ASHLAND PLANNING COMMISSION
October 9, 2018
AGENDA

- A. Approval of Findings for PA-T1-2018-00011, 294 Skycrest Drive.
- VII. **TYPE II PUBLIC HEARINGS**
 - A. **PLANNING ACTION: PA-T2-2018-00002**
 - SUBJECT PROPERTY: 880 Park Street**

- OWNER/APPLICANT: Tudor Properties, LLC/Kistler Small + White, LLC**
 - DESCRIPTION: A request for Site Design Review approval to construct a 15-unit apartment complex consisting of six apartment buildings, a separate 221 square foot laundry facility and a 30-space parking lot for the property at 880 Park Street. The application includes requests for Exception to the Street Standards to retain the existing asphalt multi-use path along Siskiyou Boulevard and to construct a meandering sidewalk along the subject properties Park Street frontage rather than installing new city standard sidewalks and parkrow planting strips, and for a Tree Removal Permit to remove five trees greater than six-inches in diameter at breast height (d.b.h.), including two Green Ash (*Fraxinus pennsylvanica*), one Modesto Ash (*Fraxinus velutina*), and two Redwoods (*Sequoia sempervirens*) including a multi-trunked cluster with five trunks of diameters ranging from eight- to

Figure 2 Demonstrating change in set back and 2 foot 8 inch off set instead of required 5 foot against abutting property lines. With changing depth that is not continuous with the 10 foot set back

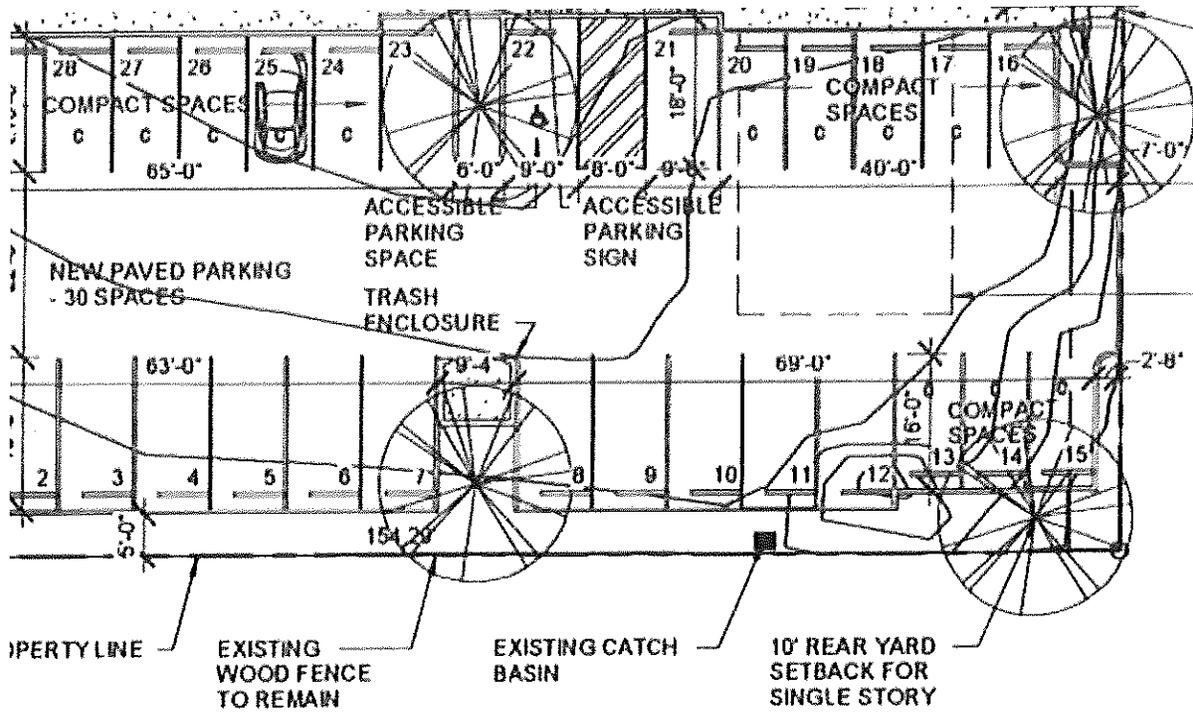
A secondary concern is the design of the parking lot. According to **18.4.4.030.F.2.a** there should be 5 foot landscaped strip shall screen parking abutting a property line. Looking at the south east edge there is only a 2’8” strip against the property line. Where in the south east side there is also a 10’ set back which suddenly changes to a 5-foot set back **see figure 2**. This warrants review by the commission to ensure it complies with intended regulations. The commission should also require the applicant to replace the fence with a substantial fence in good repair that is resistant to both light and sound unlike the current fence in place.

Figure 3 demonstrates different position of catch basin in 2 different drawings, surveyors map, drainage and landscaping lay out.

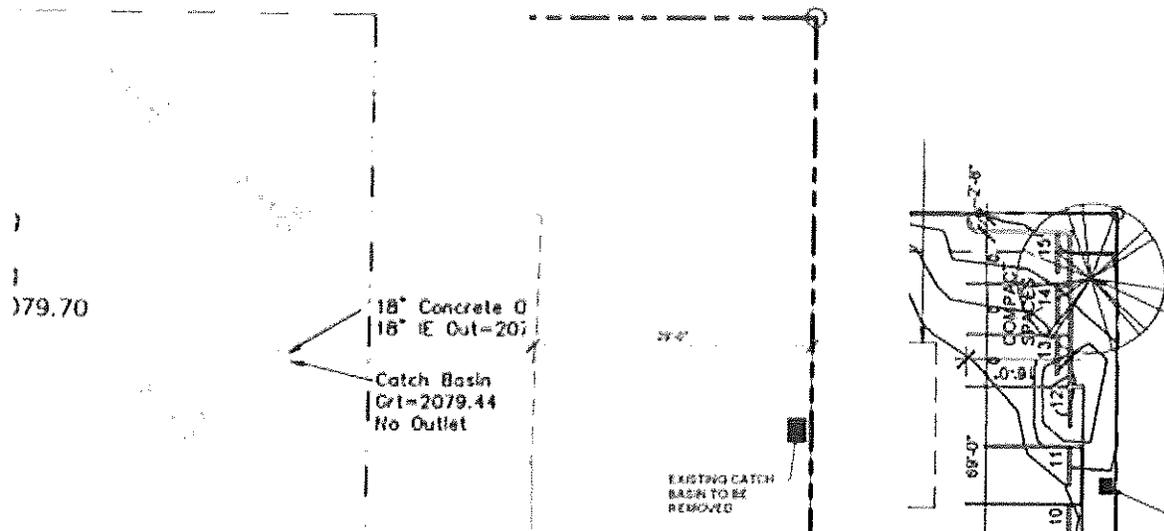
I also have concerns about the accuracy of drawings, as I review the drawings I have noticed a large discrepancy between the drawings in reference to the catch basin on the southern edge of the property. This places some doubt into the accuracy and readiness of the plans. **See figure 3**

Figure 2. Demonstrating change in setback and 2 foot 8 inch offset instead of required 5 foot against abutting property lines. With changing depth that is not continuous with the 10-foot setback

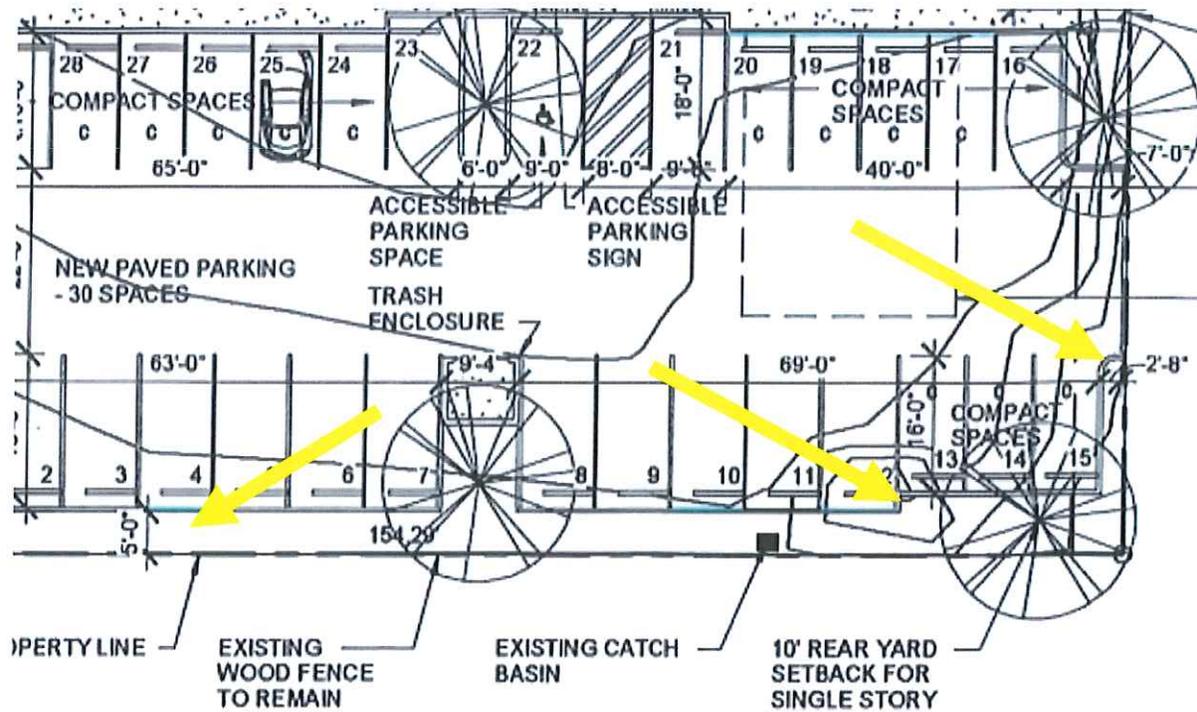
A secondary concern is the design of the parking lot. According to Ordinance **18.4.4.030.F.2.a** there should be 5 foot landscaped strip screen between any parking and a property line. Looking at the south east edge there is only a 2'8" strip against the property line. Where in the south east side there is also a 10' set back which suddenly changes to a 5-foot set back **see figure 2**. This warrants review by the commission to ensure it complies with intended regulations. The commission should also require the applicant to replace the fence with a substantial fence in good repair that is resistant to both light and sound unlike the current fence in place.

Figure 3. Demonstrates different position of catch basin in 2 different drawings, surveyors map, drainage, and landscaping layout.

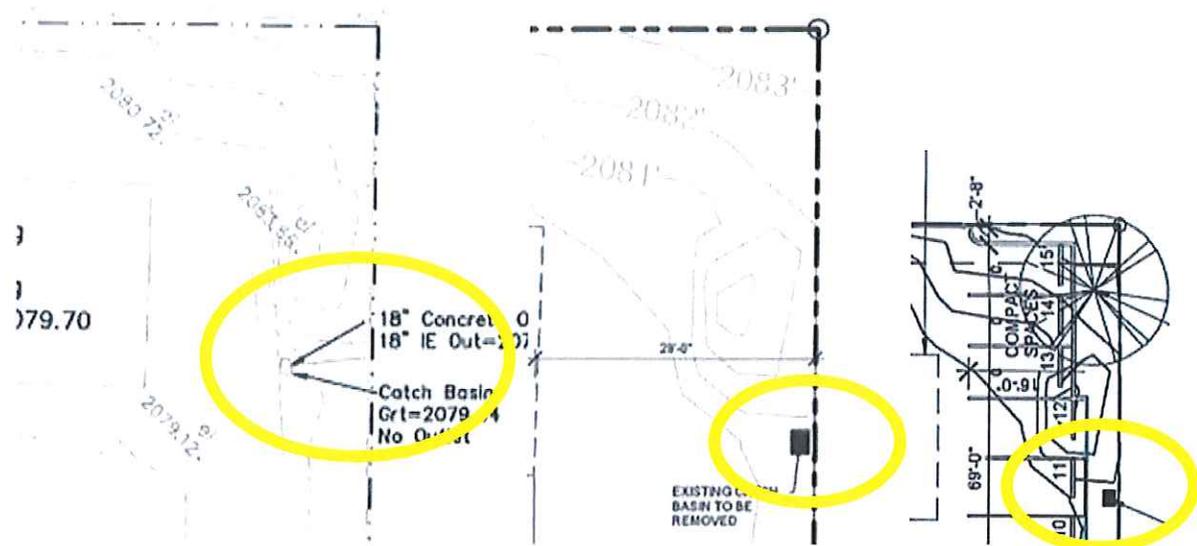
I also have concerns about the accuracy of drawings, as I review the drawings I have noticed a large discrepancy between the drawings in reference to the catch basin on the southern edge of the property. This places some doubt into the accuracy and readiness of the plans. **See figure 3**
